# A G E N D A

## Architectural Review Board

June 23, 2020 – 5:30 p.m.

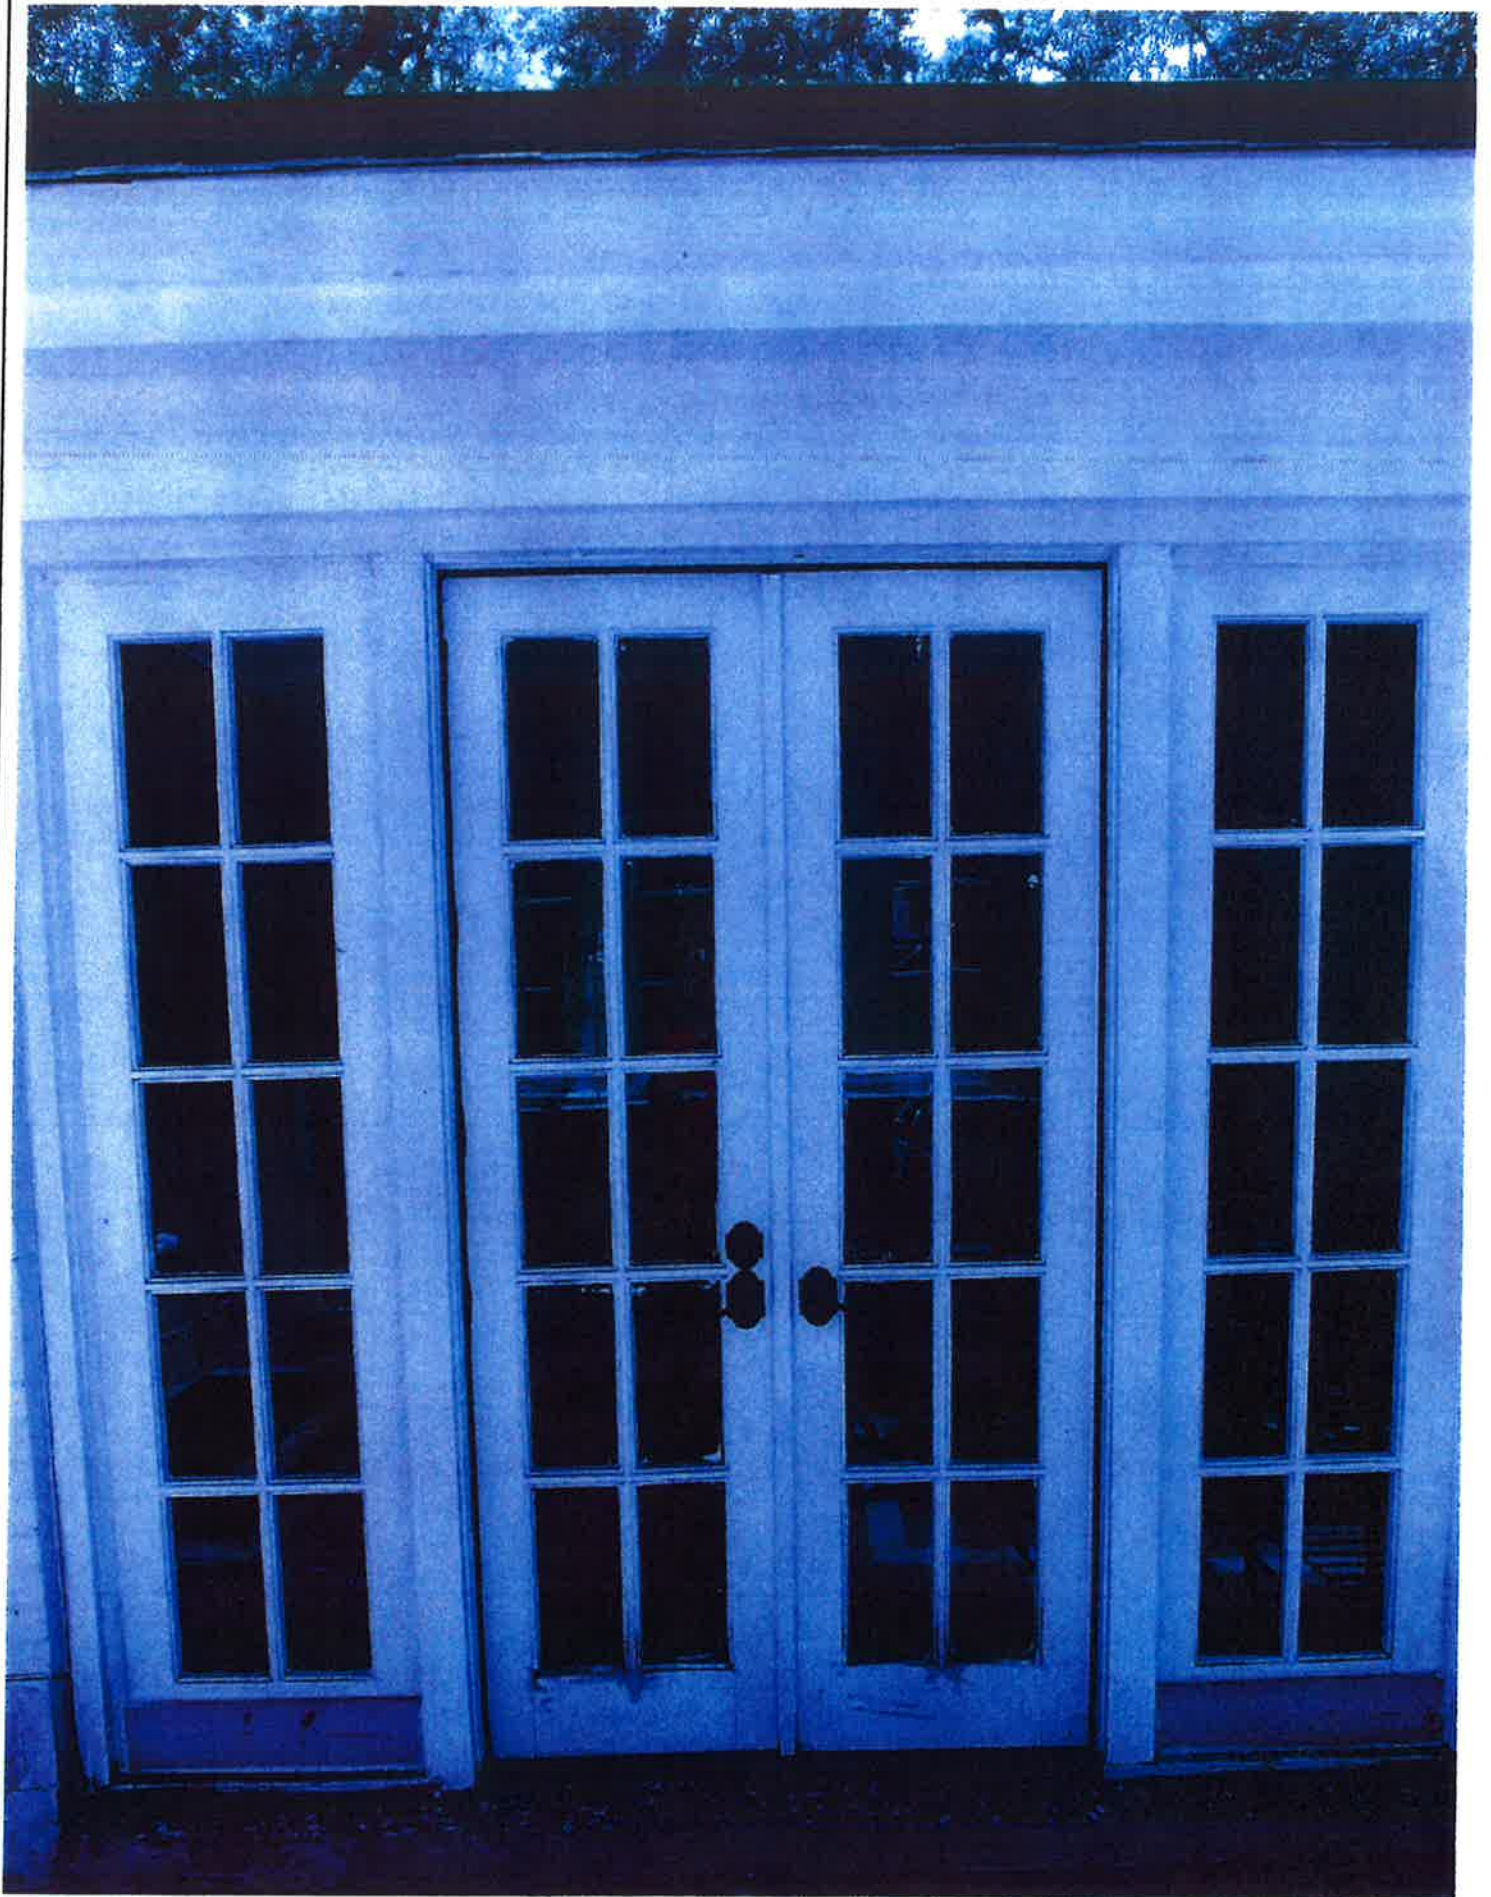
**REMARKS:** The petitioner is requesting permission to enclose an existing breezeway located between the house and garage. The project would involve removing the extant columns and installing a door and sidelight system as illustrated. The doors and sidelights are wood with 10 true divided lites.

- When agenda photos were taken, it appeared that work had begun and didn't quite match the description of work in the application. At the time the agenda was prepared, clarification had not been received from the owner.
- No objection to the project as submitted; however if the current sidelights are intended for use that will require introducing a siding material that was not previously proposed and would need to be specified.

2225 College Street

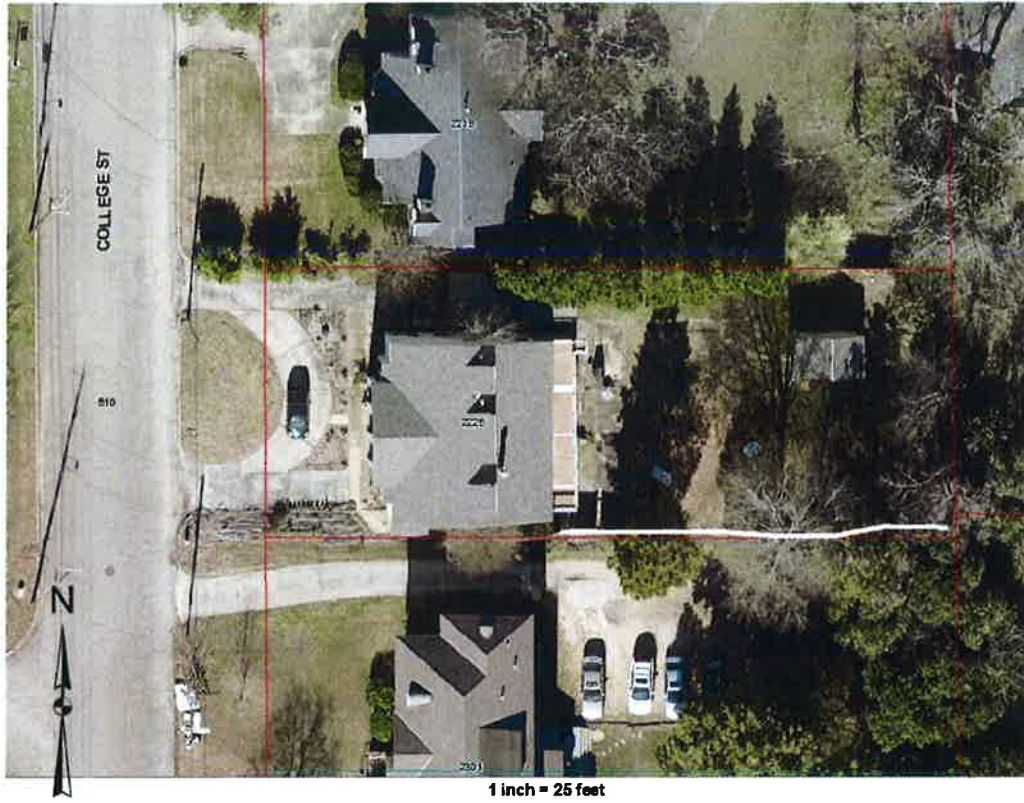
- Replace the existing single door and sidelights with a double wood door within the same opening. Option A is the preferred door style, option B is “plan b”.
- Replace an existing (and failing) wood privacy fence on the south property line which is shared with an apartment building with a concrete wall 6’ high and approximately 8” wide. The wall would run from the rear corner of the house to the rear property line. An illustration from elsewhere in the neighborhood is attached as an example.
- Landscaping proposed is minimal, the bulk of which is in the right of way and will be done in consultation with the urban forester.

- Door Option A is fairly modern, but previous modifications to the house have also made it more modern. Option B would be a more traditional choice.
- No objection to the wall.

8E

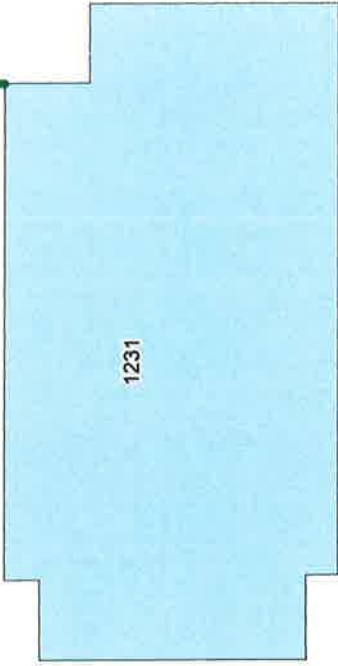
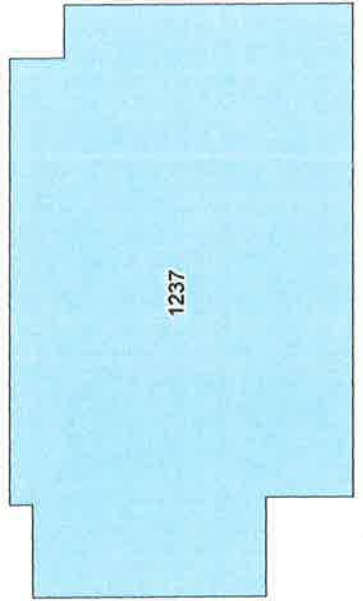
**REMARKS:** The petitioner is requesting permission to retain an 8' dog eared privacy fence installed on the north and east property lines with a return to the house on the north side, replacing sections of 6' and 7' sections of fence. The 8' height will also require a variance from the Board of Adjustment if approved. The petitioner would also like approval to match the new fence, if and when the fence on the south property line is replaced.

- Recommended height of fences per ARB guidelines is 6', zoning allows 7'. ARB has approved higher fences if circumstances warranted it.

I am seeking permission, after the fact, for a variance for the height of a new back fence. I recently replaced three sides of my backyard fence and incorrectly assumed I could raise the back height to 8 ft. to become the same height as the front and one side of the prior fence. I thought I had touched all the bases to do this without having to bother the city: reviewed other fences, contacted one neighborhood owner who was replacing his fence with a similar height to the one I desired, discussed at length with all adjoining neighbors and a few others not adjoining. My desire was to have a consistent height all around, various security issues, and privacy issues. The prior back fence was 6" on top of cinder blocks, for a total height of 6 feet 7.5 inches. If I understood Mrs. Anderson correctly, 7 feet is allowed without a variance. As my new height is 8 feet, I am requesting approval for this height. If approved, it will only be 16.25 inches higher than the previous fence section and 12 inches over the allowable height.
